REF. NO	PART NO	DESCRIPTION	DETAIL DRG. NO	NO/LOCO	MATL	SPEC.
						RDSO/2008/EU/Spec/0864 (Rev' 0)
REF			APPD. BY <i>[Signature]</i>		(FOR DG)	
Punched Type Resistance Rings Mechanically Interlocked to Endplate Design of Rotor for Traction Motor type 6 FRA6068 for WAG9/WAP7 locos					FIRST ISSUED June - 2008	
					SUPERSEDES -	
R.D.S.O.ELECT. DTE					SKEL-4742	
					SUPERSEDED BY -	
					ALT-'0'

DETAIL H
SCALE 1 : 2

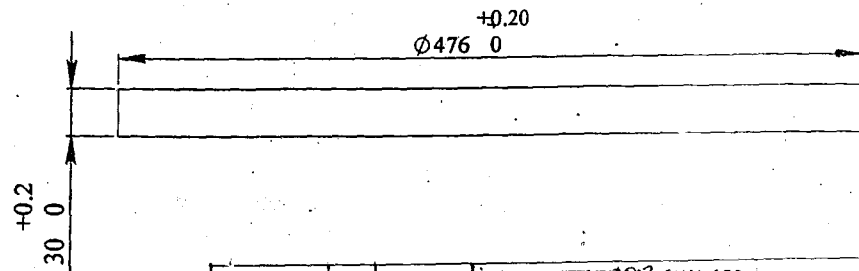
STATUS	ALT.	REF. NO	DESCRIPTION	APPD. BY	DATE
	1	SKEL-4742	DIM R179.5 +0.2 CHANGED TO R180.5 +0.2. ROOT RADIUS R1 m.m. INCORPORATE AT CORNER OF VETAL STEP. 421PCD CORRECTED AS Ø 421.	<i>B. J. ...</i>	27-8-15
